Ocean Park Master Redevelopment Project
As-built Remediation Plan (Rev. 3)

Environmental Permit No. EP-249/2006/A - Condition 2.8

**Land Contamination Assessment
Citybus Depot Site at Wong Chuk Hang**

Response to EPD's Comments Received on 2 March 2007

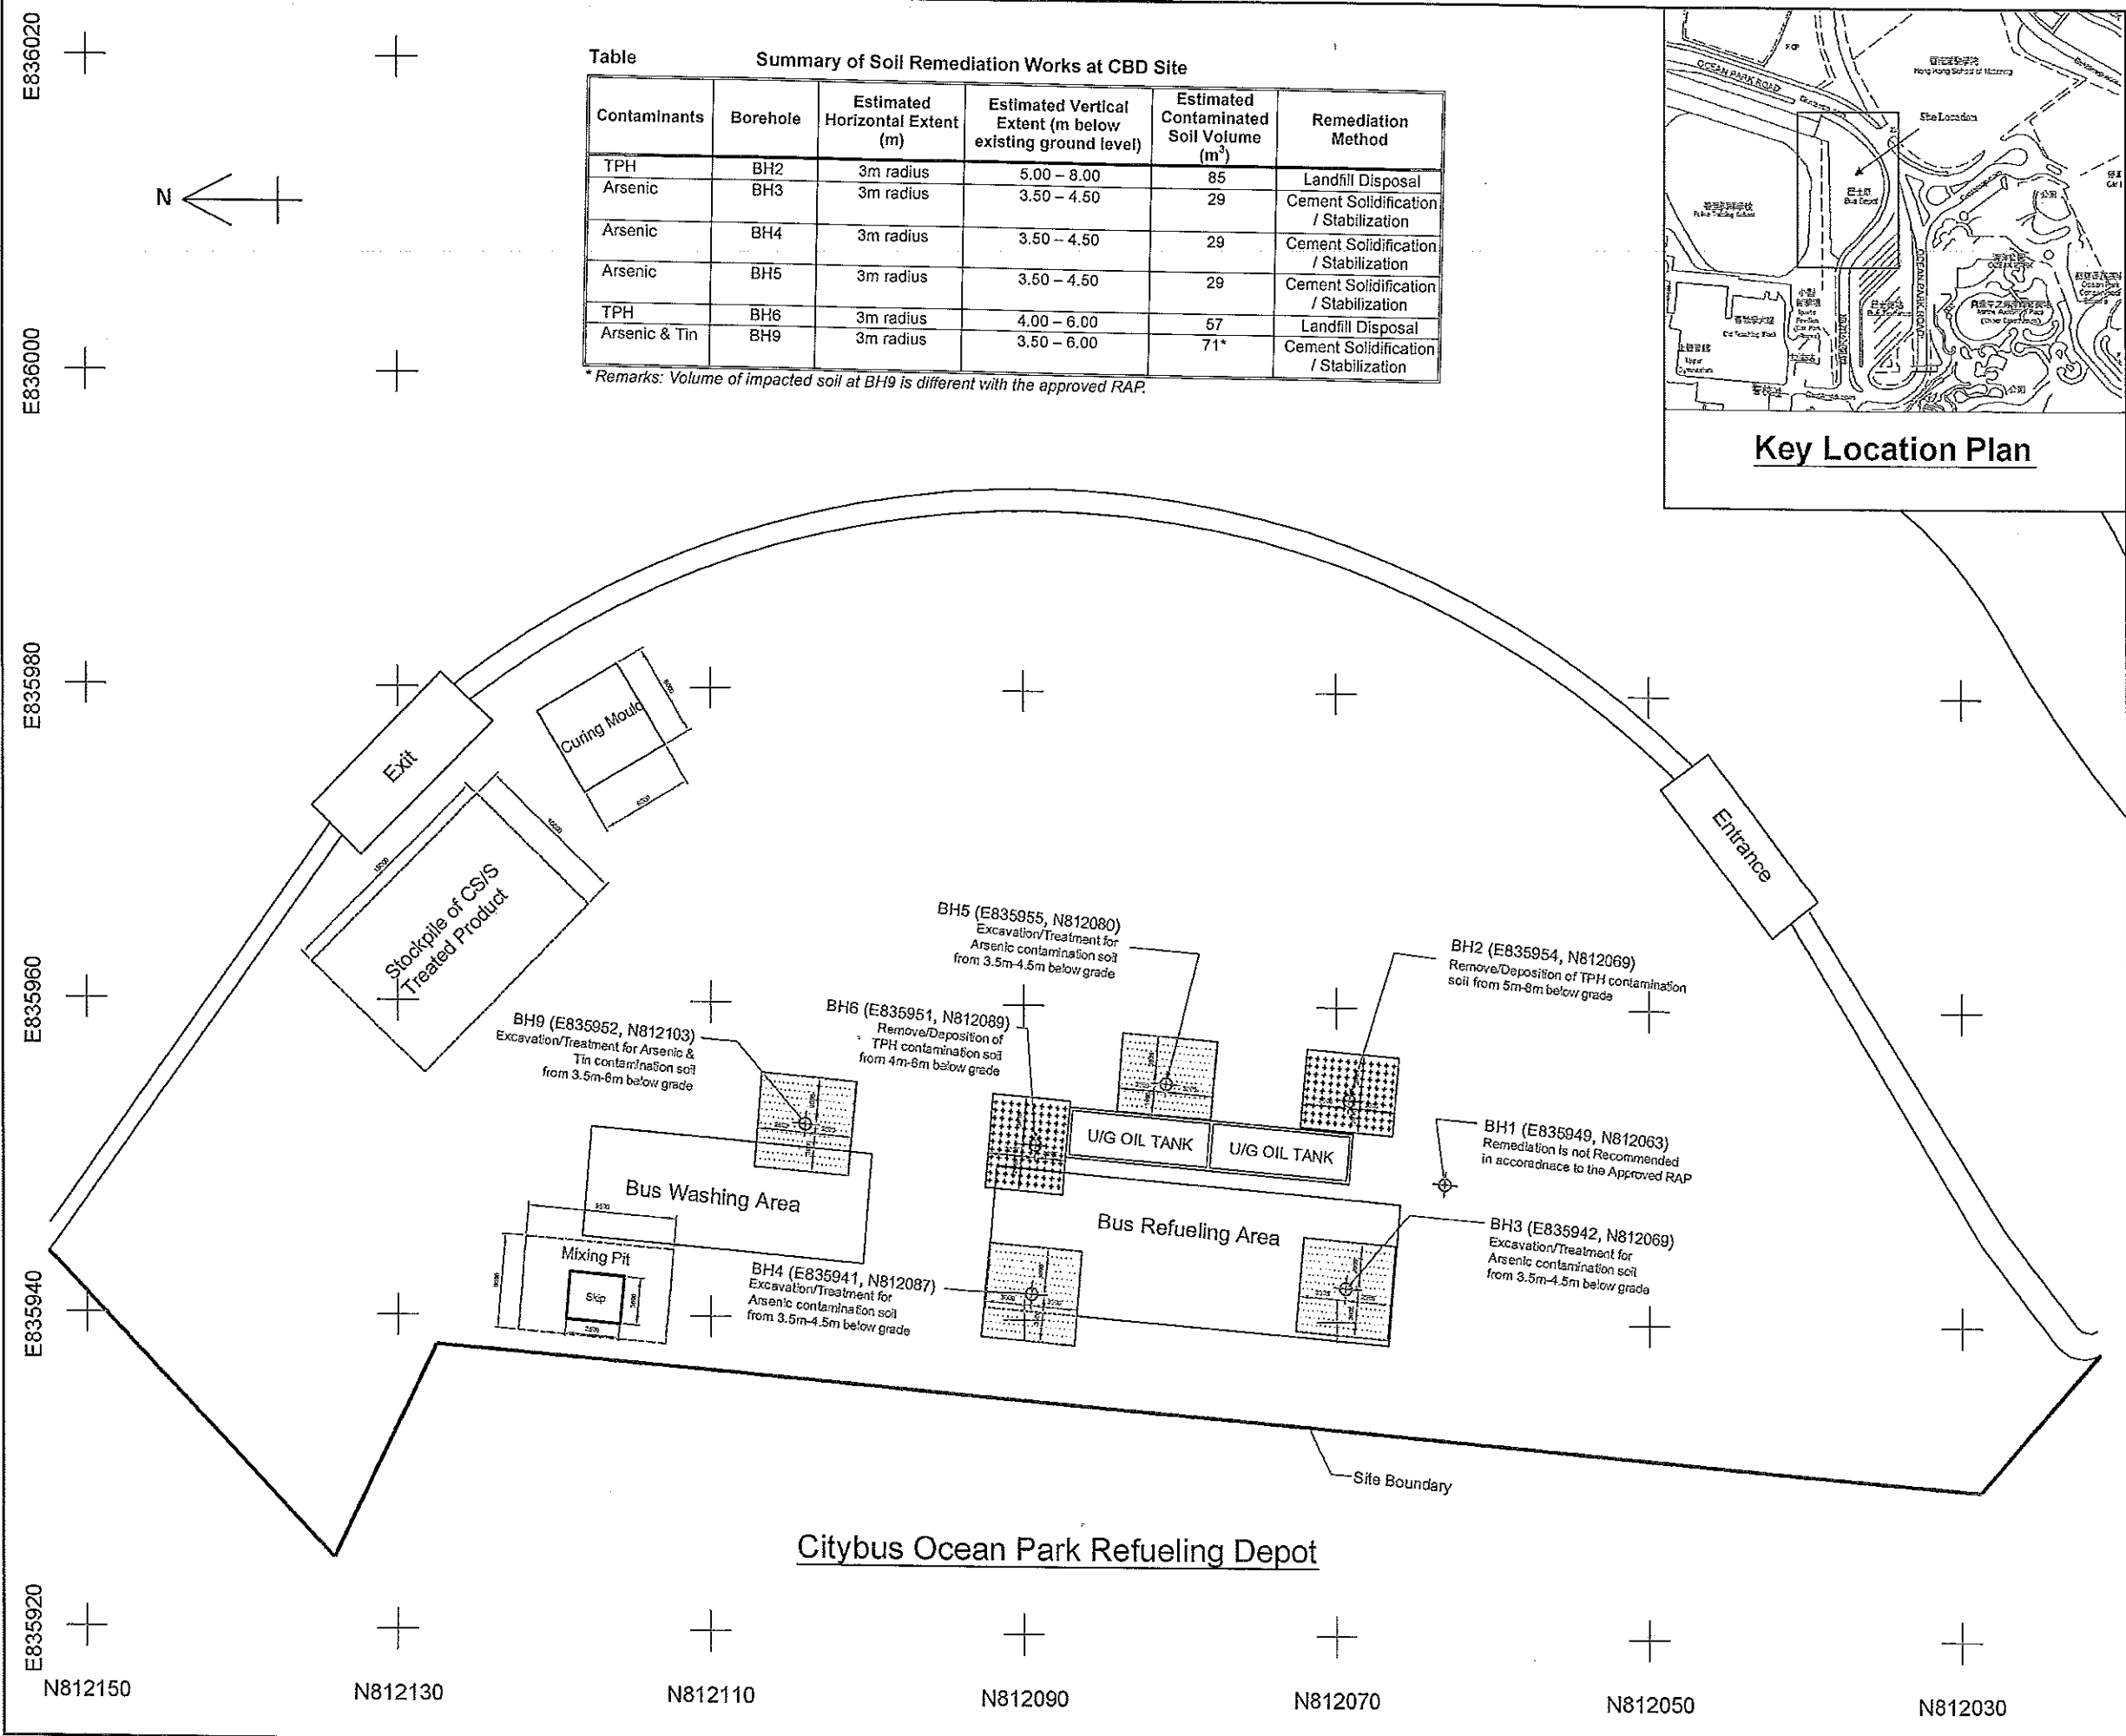
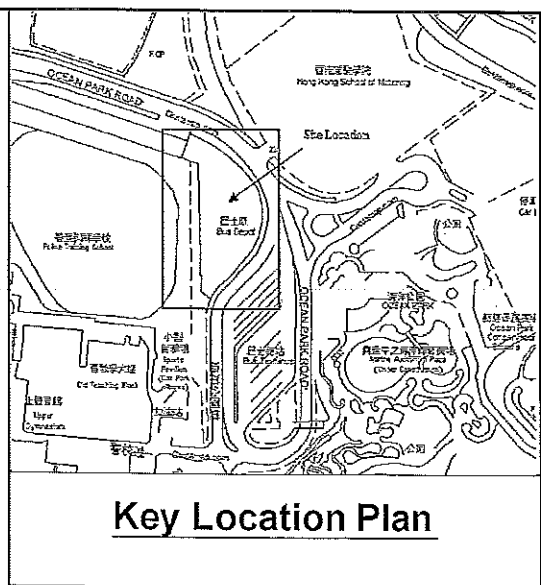
Item	Section	EPD's Comments	Response to EPD Comments
1	The as-built remediation Plan	The plan lacks a key location plan or co-ordinations for reference	Noted. The Key Location and co-ordinations are adopted.
2		The Plan lacks a legend to explain various types of signs and symbols.	Noted. The legend to explain various types of signs and symbols are adopted.
3		Treatment method adopted for each contaminants should be clearly indicated	The treatment methods are provided in the additional table, which are clearly indicated treatment method in each contaminant.
4		A summary of soil remediation works at the site such as similar to Table 2-1 of the report could be incorporated in the plan for information completeness.	Noted. The Table is incorporated. Please see the revised As-built Remediation Plan.
5		If necessary, additional notes should be added to facilitate understanding of the plan, and/or reference to other related documents.	Noted. The excavation plan document reference is added.

6		Typo "Bus Wasling Area" should read "Bus Washing Area"?	Noted and amended.
7		The revised plan should be certified and verified by the ET Leader and IEC respectively.	Noted. The revised plan has been certified and verified by the ET Leader and IEC respectively.
